**RESPONSE TO BRISBANE CITY COUNCIL INFORMATION REQUEST: S.13 OF THE
DEVELOPMENT ASSESSMENT RULES**

**CHANGE APPLICATION (OTHER CHANGE) PURSUANT TO S82 OF *PLANNING ACT 2016* OVER
LAND AT 10-12 CREMIN STREET AND 1-5 PLAYER STREET, UPPER MOUNT GRAVATT (LOTS
50-51 ON RP103193 & LOTS 68-70 ON RP103193)**

COUNCIL REFERENCE: A007015770

Figure 1: Stage 1 Communal Open Space and Landscaping (Source; Nettleton Tribe, 2026)

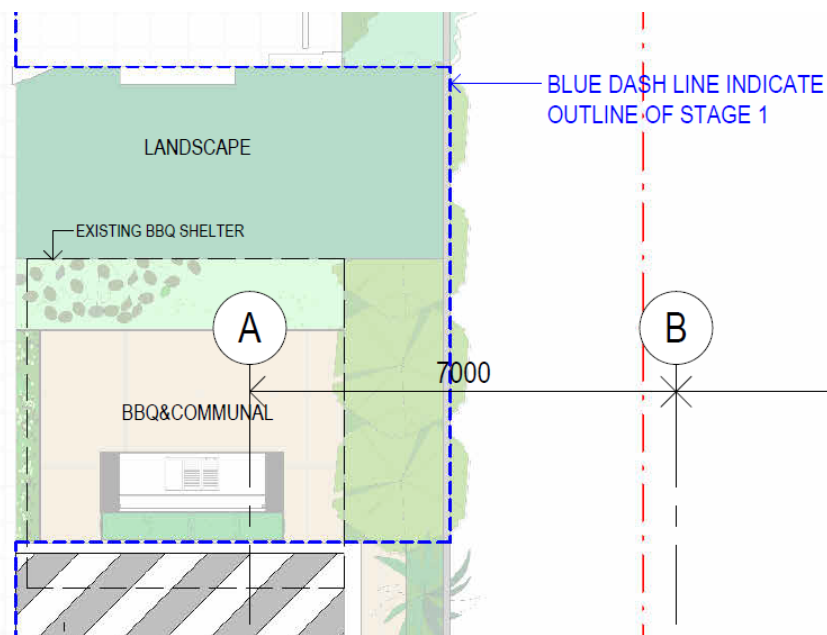
- (a) *Submit amended plans and documents to provide a consistent and clearly delineated boundary between Stage 1 and Stage 2. Specifically:*
- i. *The existing communal open space area and landscaping shown on A004513189 and A006226364 are to be located within Stage 1, commensurate with serving the approved Stage 1 dwellings.*
 - ii. *Visitor car parking spaces are to be clearly marked on the plans as either being Stage 1 or Stage 2 visitor car parking spaces Under v3.01/2016 of Brisbane City Plan 2014 (City Plan), Stage 1 is to have a minimum of two (2) visitor car parking spaces as per AO13/PO13 of the Transport, access, parking and servicing code.*

- The existing communal open space area and landscaping (approved by way of **A004513189** and **A006226364**) wholly within the Stage 1 boundary. Refer to the revised Architectural Plans prepared by Nettleton Tribe (**Attachment B**) and **Figure 1** below, for further detail.

Figure 2: Stage 1 and Stage 2 Visitor Carparking Arrangement

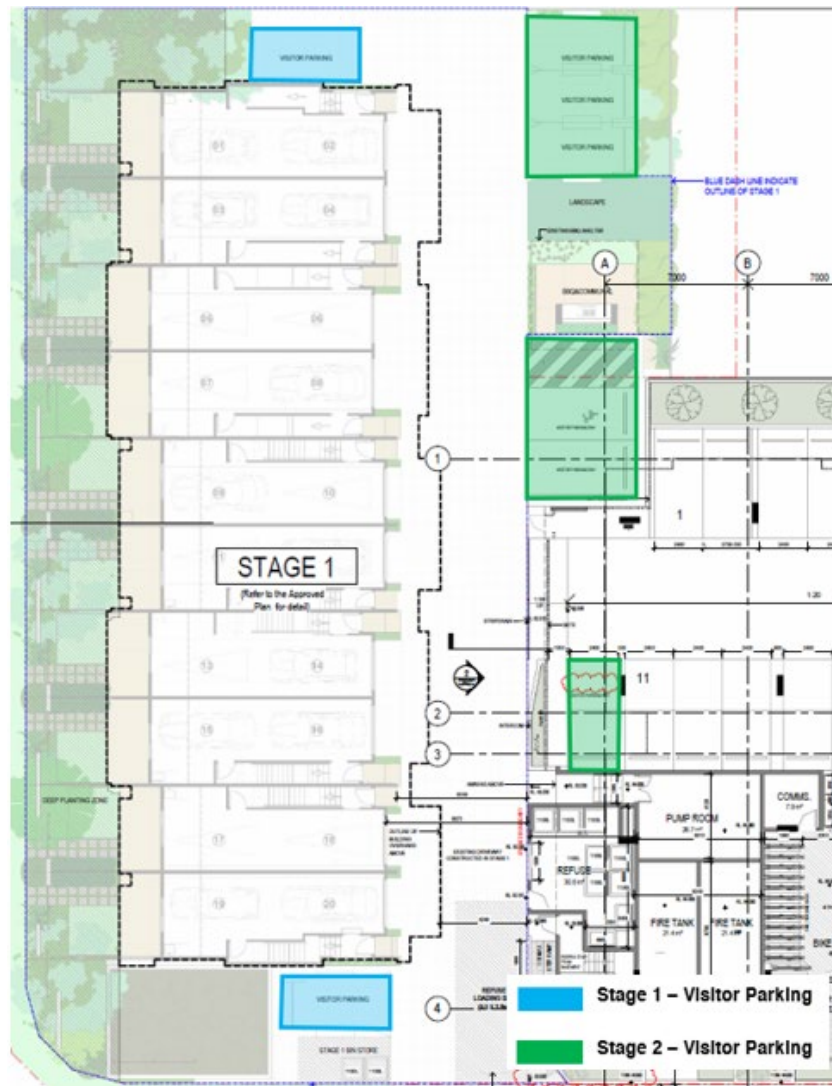
- (a) Submit amended plans to provide a minimum of six (6) visitor parking spaces for Stage 2 to account for the proposed increase in units.

- The visitor car parking spaces have been clearly marked on the Architectural Plans as either Stage 1 or Stage 2 visitor parking spaces, in accordance with **Item 1(a)(ii)** of Council’s Information Request. As detailed further in response to Item 2 of Council’s Information Request, visitor car parking is provided within both respective stages, as follows:
 - Two (2) visitor car parking spaces have been provided for Stage 1 (in accordance with the original development approval); and
 - Six (6) visitor car parking spaces have been provided within Stage 2.

Refer to the revised Architectural Plans prepared by Nettleton Tribe (**Attachment B**) and **Figure 2** below, for further detail.

In response to **Item 2** of Council's Information Request, the Architectural Plans have been amended to include a minimum of six (6) visitor car parking spaces for Stage 2 to appropriately account for the proposed increase in residential units. **Table 1** below outlines the changes made to the proposed car parking arrangement to facilitate the additional visitor car parking space within Stage 1.
